Colorado Interstate  
Gas Company, L.L.C.  
a Kinder Morgan company

Re: Colorado Interstate Gas Company, L.L.C.;  
Docket No. CP19-56-000;  
Supplemental Environmental Information

COLORADO INTERSTATE GAS COMPANY, L.L.C.  
Response to OEP Data Request  
Dated February 21, 2019 in Docket No. CP19-56-000  
CIG High Plains Kiowa Lateral Expansion Project

TITLE  
**I-76 CROSSING**

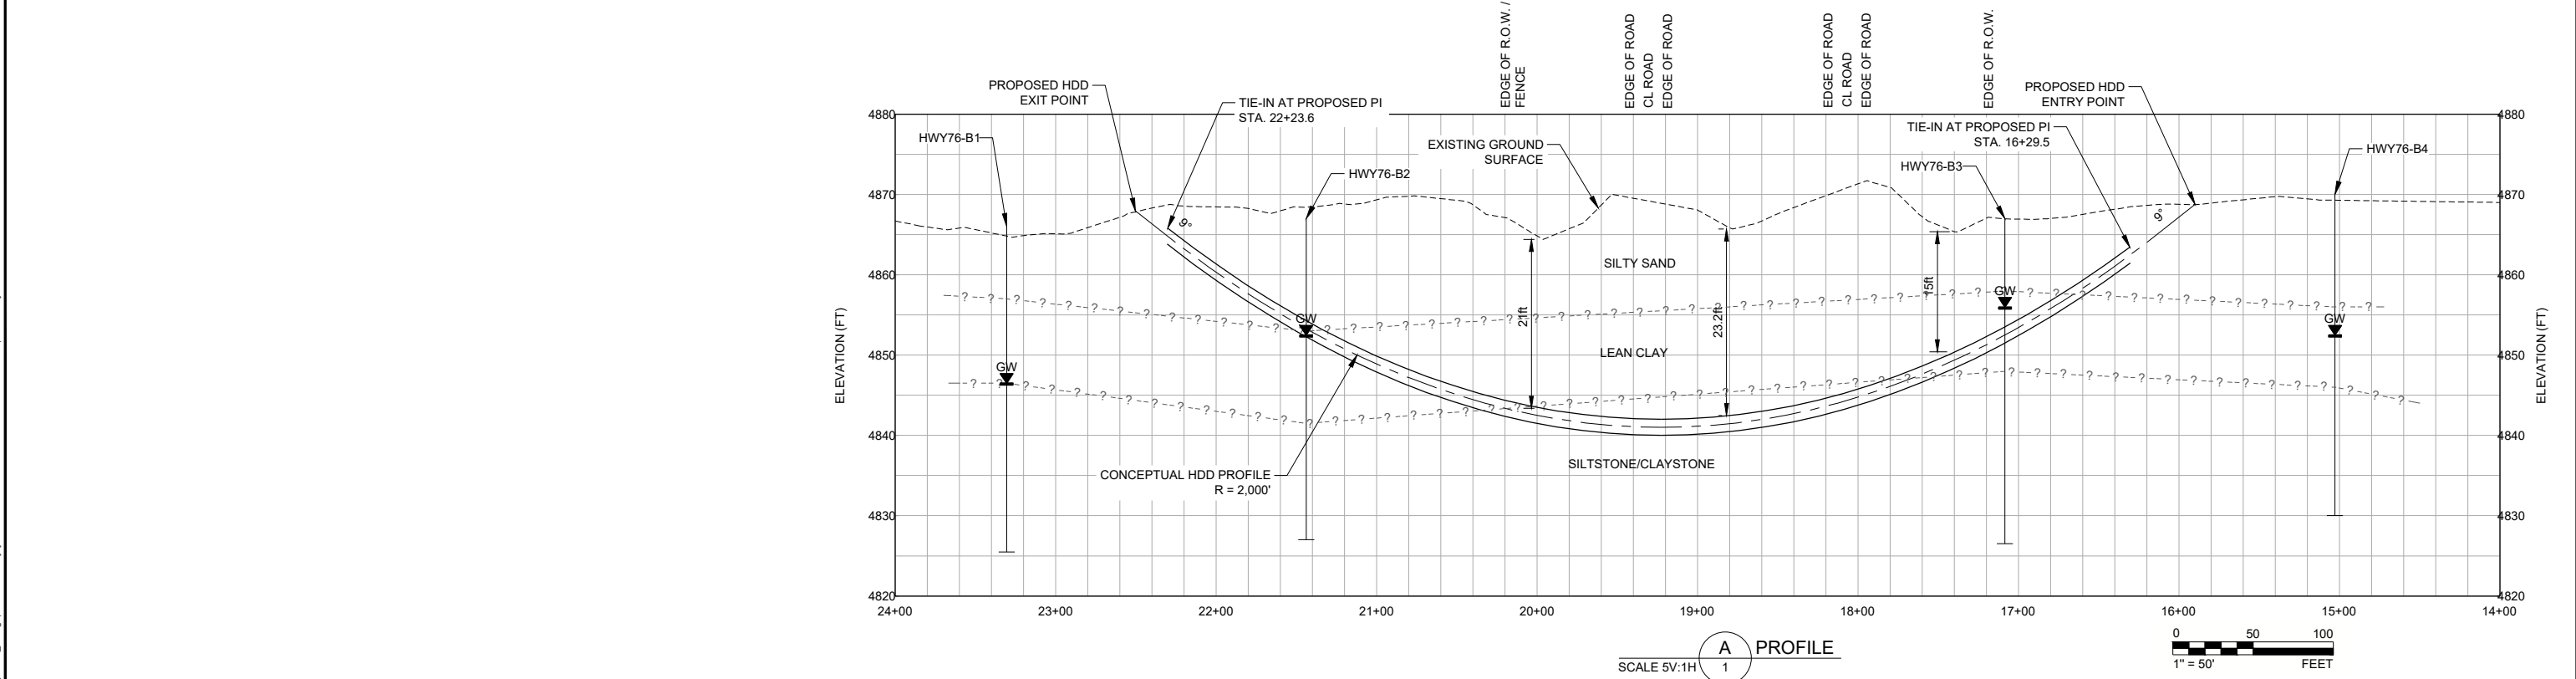
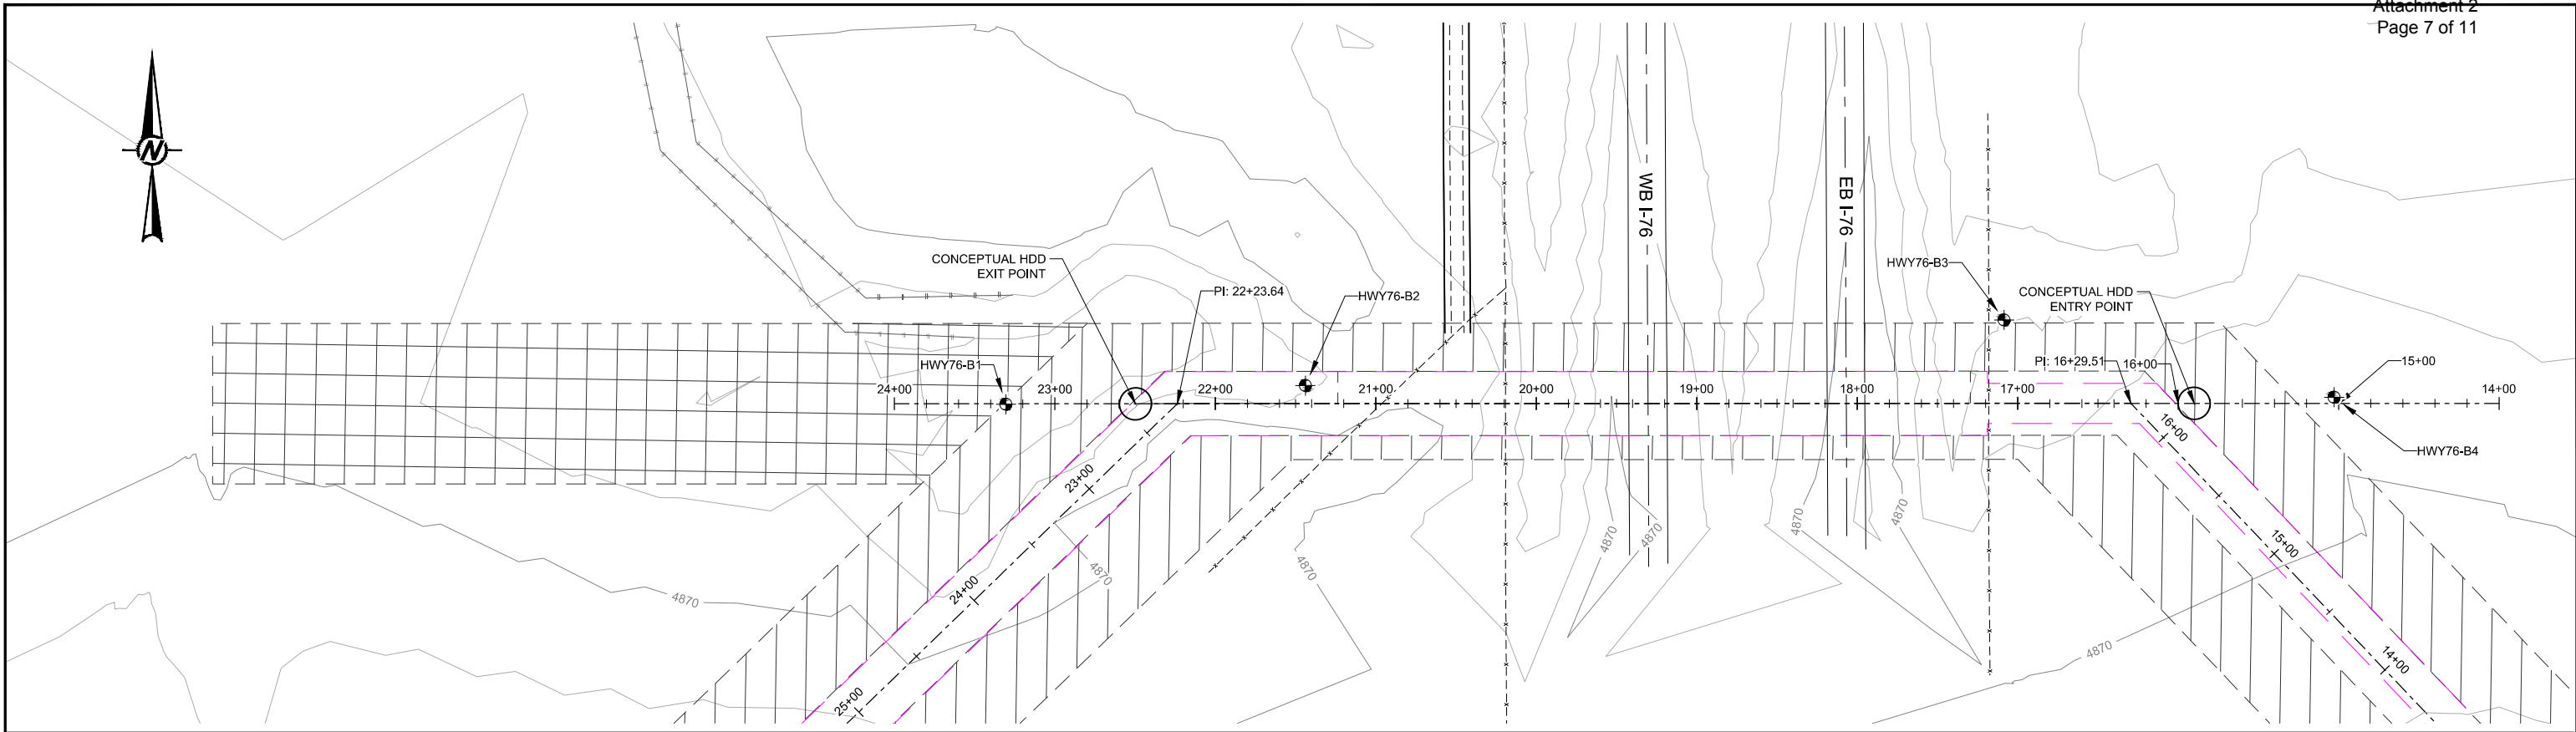
7. For each planned HDD crossing, provide an alignment profile that incorporates site-specific geotechnical investigations (subsurface lithology along the drill path and the top of the water table [zone of saturation], Standard Penetration Test results, soil mechanic properties/Atterberg Limits, rock coring results including core recovery, and Rock Quality Designation for each bedrock core run).

The Concept HDD Layouts which include subsurface lithology, groundwater elevations, as well as other geotechnical information are provided in the Golder Technical Memo dated March 18, 2019. Please see Attachment 2 behind this response for the analysis of the HDDs. Also, CIG is providing the Terracon Geotechnical Report dated December 28, 2018 for additional geotechnical information being provided as Attachment 3 behind this response.

**Annular Pressure Diagrams**

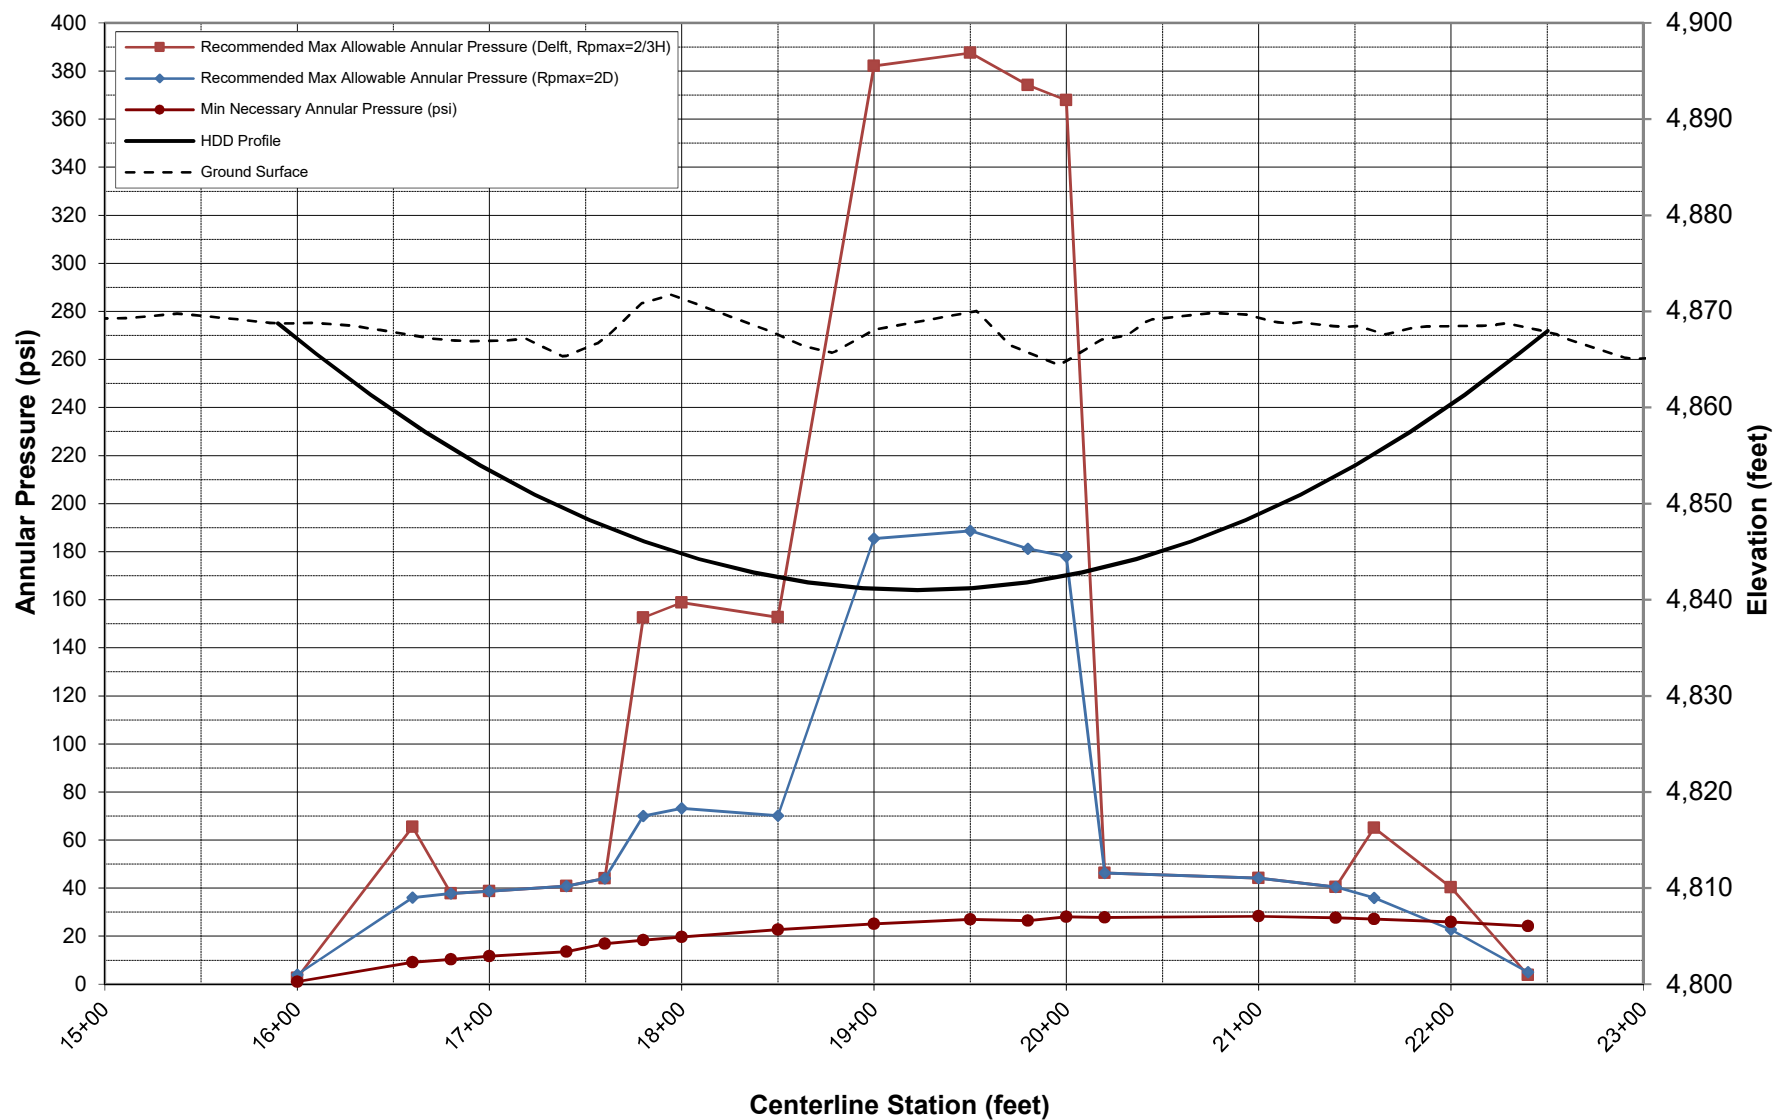
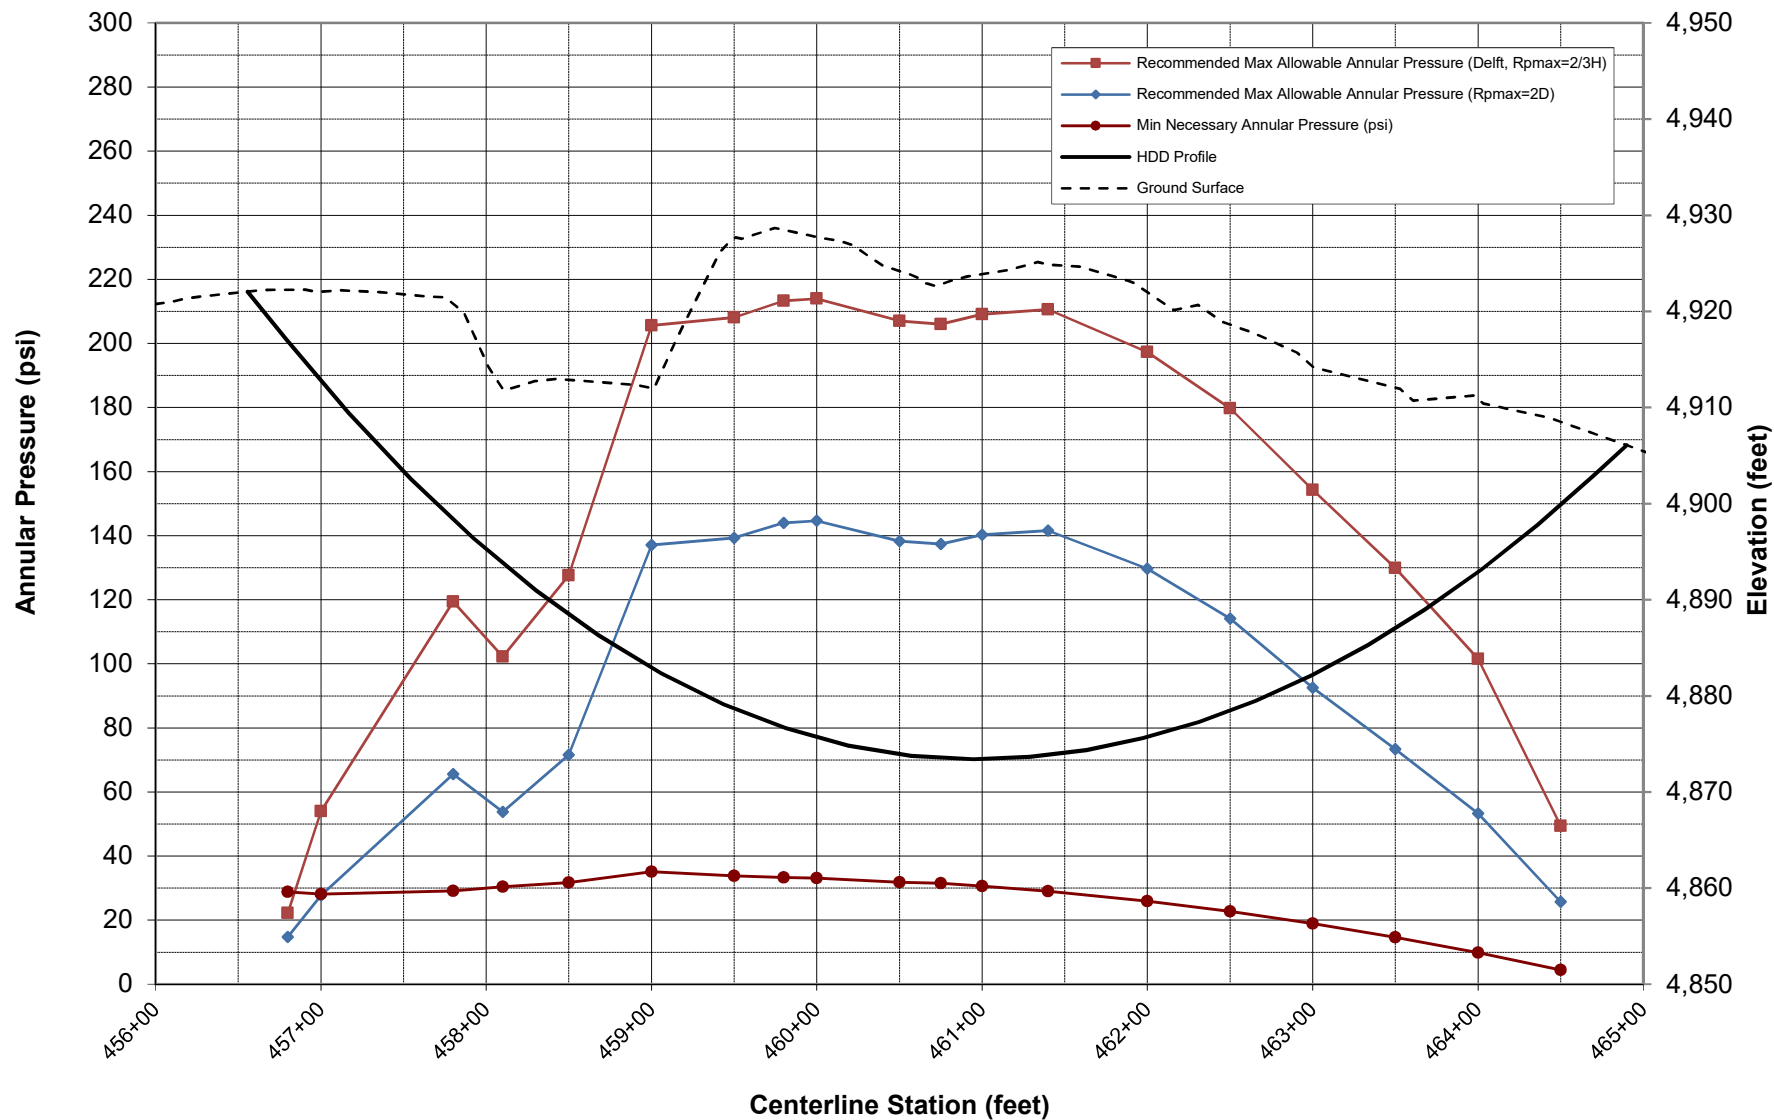
8. For each planned HDD crossing, provide an HDD assessment which includes a description of:

- a. the likelihood of success for each drill;
- b. any subsurface conditions that were identified as a result of geotechnical investigations that may increase the risk of HDD complications (e.g., unplanned inadvertent returns, drill hole collapse, contamination); and
- c. the measures that would be implemented to minimize these risks.

In Section 2.1 and 2.2 of the Golder Technical Memo dated March 18, 2019, which is provided in the response to General Question 7, the risk of hydrofracture and inadvertent return of drilling fluid is analyzed for the two HDD crossings using the US Army Corps of Engineers Delft Method. As identified in Section 3.0, the risk of inadvertent returns for the I-76 is identified as low to moderate and is identified as low for the WCR 49 crossing.

Figure 1. Schematic decision-making tree for cultural resource discoveries.

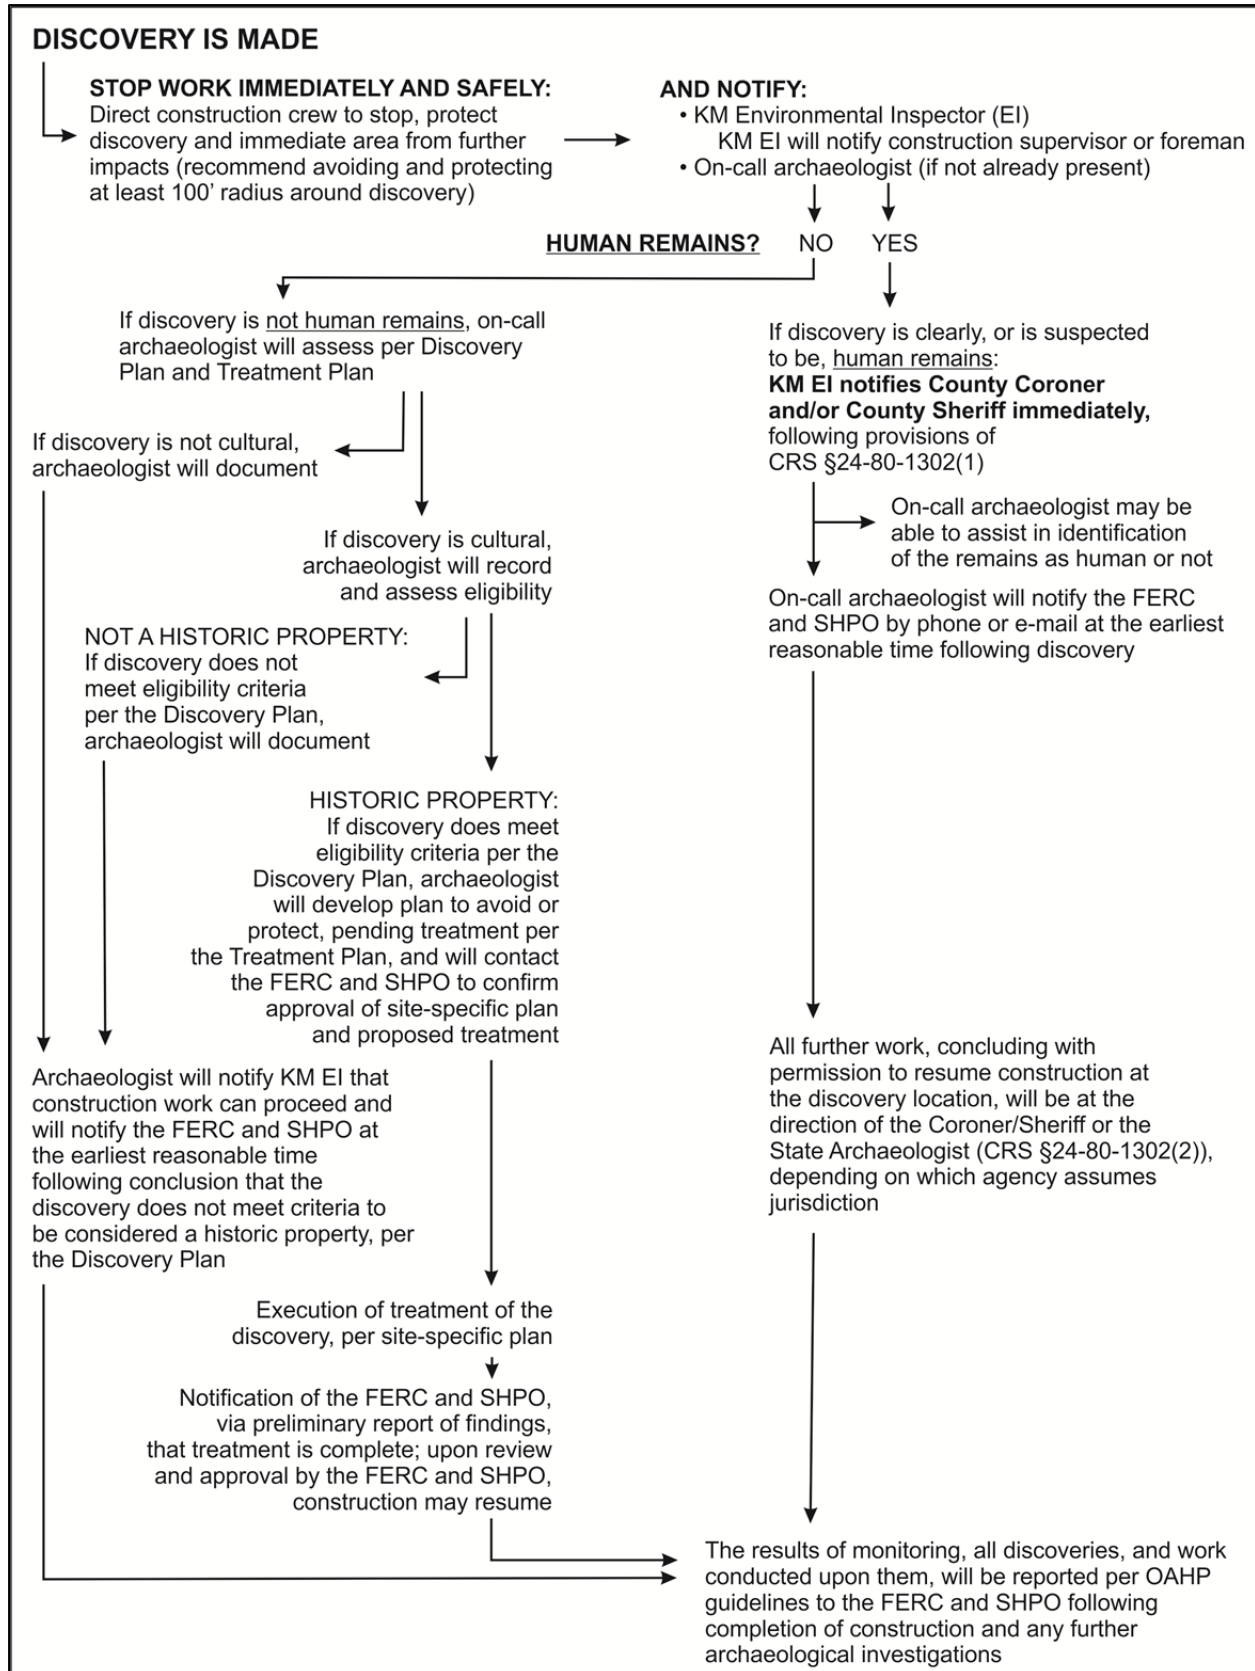
7. The treatment plan needs a discussion on consultation with tribes, agencies, and other interested parties as appropriate for treatment of historic properties that may be affected by the proposed Project. File the revised plan.

The procedural flow-chart presented in Figure 1 shows the decision-making and notification process Metcalf recommends in the case of a cultural resource or human remains discovery on the project. This is based on substantial experience with similar FERC-jurisdictional pipeline projects and follows several basic sequential steps. In the event that the discovery involves human remains, the notification and investigation process is statutorily determined by Colorado's Unmarked Human Graves law, CRS §24-80-1301-1305, as described in more detail in the Unanticipated Discoveries Plan for this undertaking (under separate cover).
